Hunterston Marine Construction Yard
Response to letter dated 2 November 2018

We write on behalf of our clients, Clydeport Operations Ltd, in response to your letter dated 2 November 2018 in which you requested clarification and further information on the proposed construction works to upgrade the hammerhead quay at the above site. Responses to your comments are provided below.

Title
**Hunterston Construction Yard:
Proposed Works Outline 2019**

Drawing No. 168612-019 Redacted	Revision B
---	----------------------

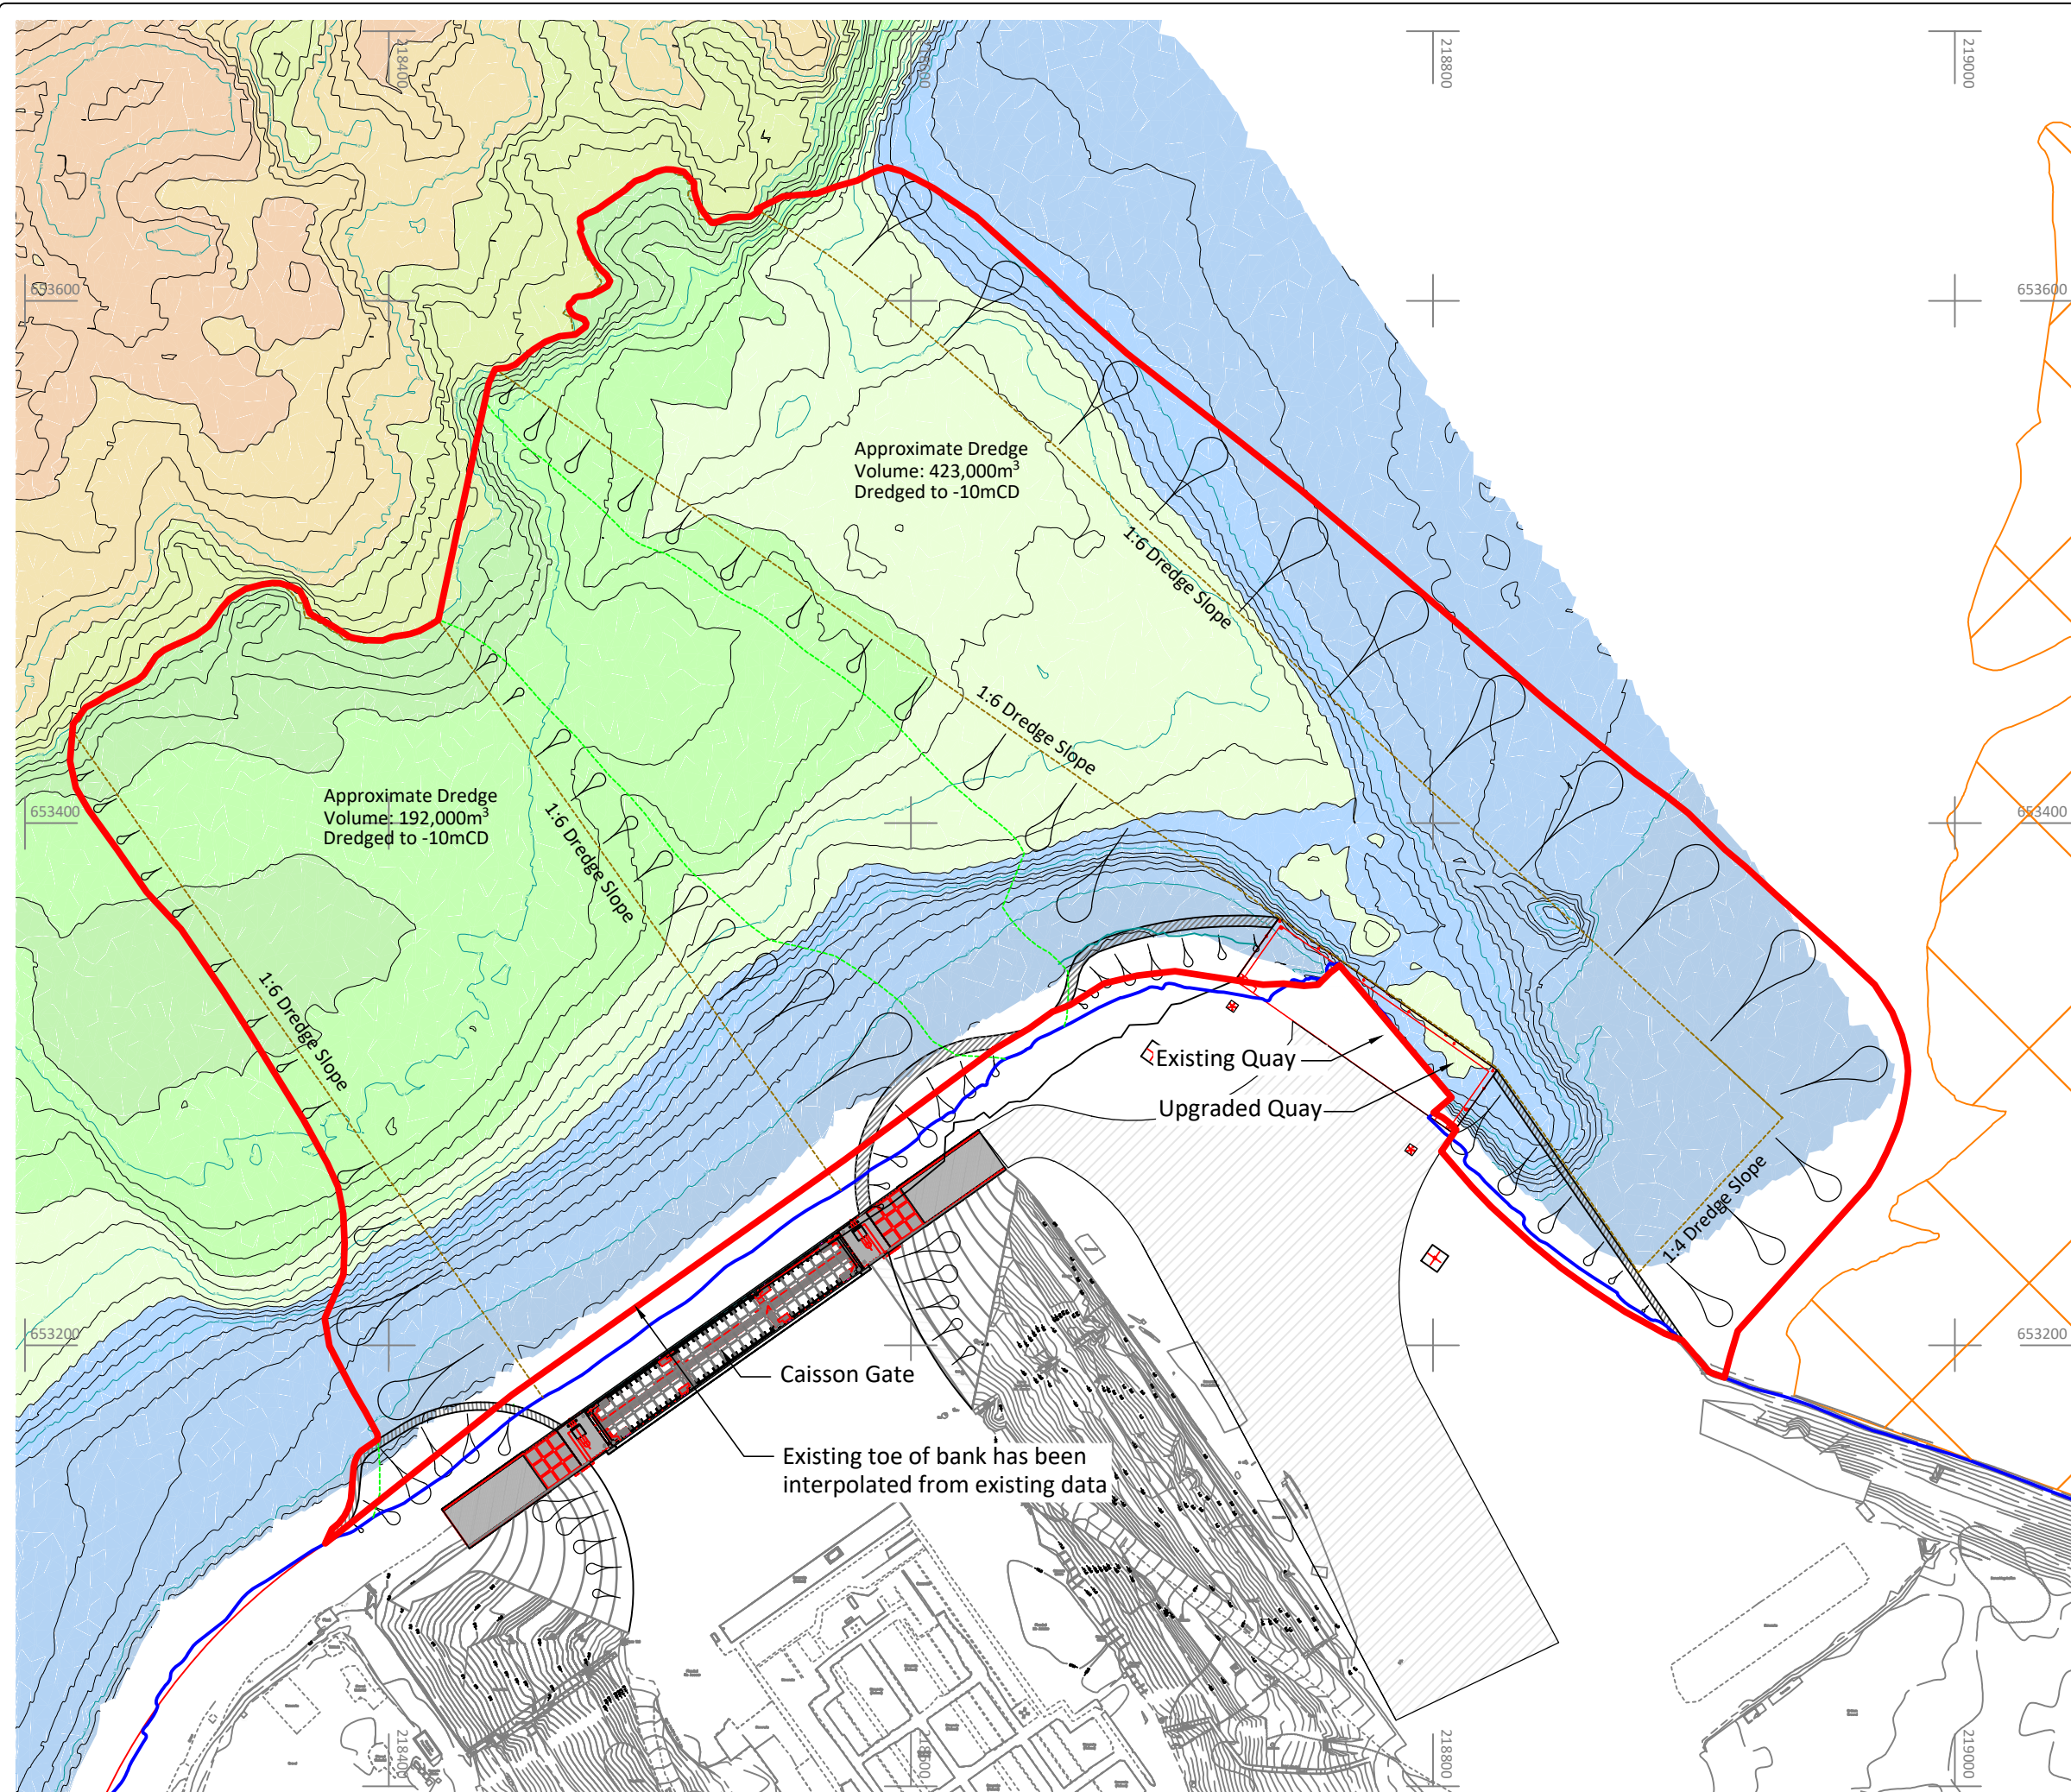
3. Proposal for construction of Quay

4. Extent of revetment works

8. Relevance of Previous Environmental Review to 2019 Designs

Drawing 168612j-019 Rev B – This shows the extent of the proposed works, the position of the existing and upgraded quay with outlines of the envelope for dredging and the position of the Caisson Gate (which is being built and erected out with the marine environment);
